Site Plan Update Ann Arbor CPC

April 7, 2026

SOUTHTOWN
RESIDENTIAL HOUSING
DEVELOPMENT

SITE PLAN CHANGES

Figure 2 – Podium and tower design of SP23-0017 (1601 S State St) approved September 5, 2023.

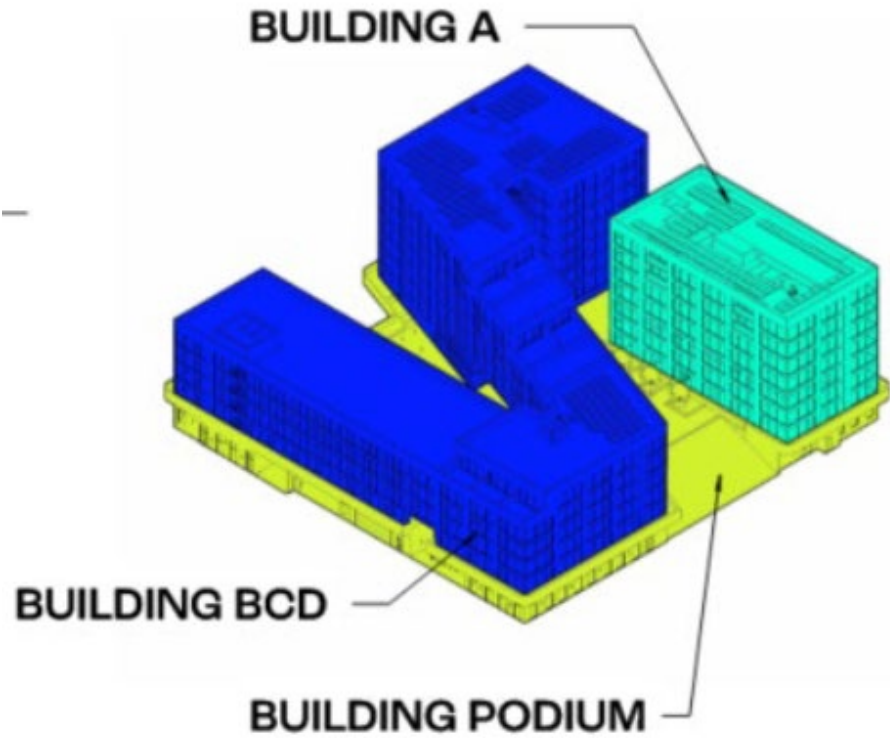
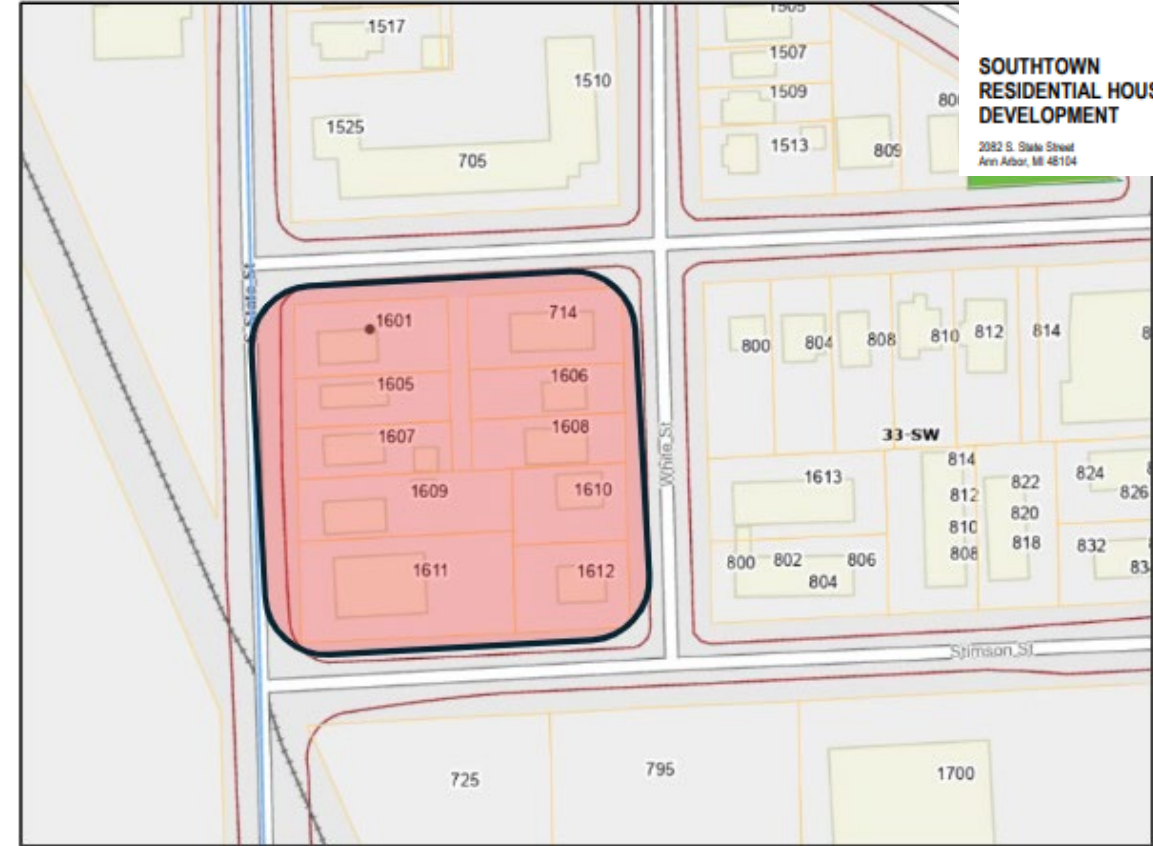
ORIGINAL PLAN

REVISED PLAN

MEETS OR EXCEEDS REQUIREMENTS; REDUCED INTENSITY
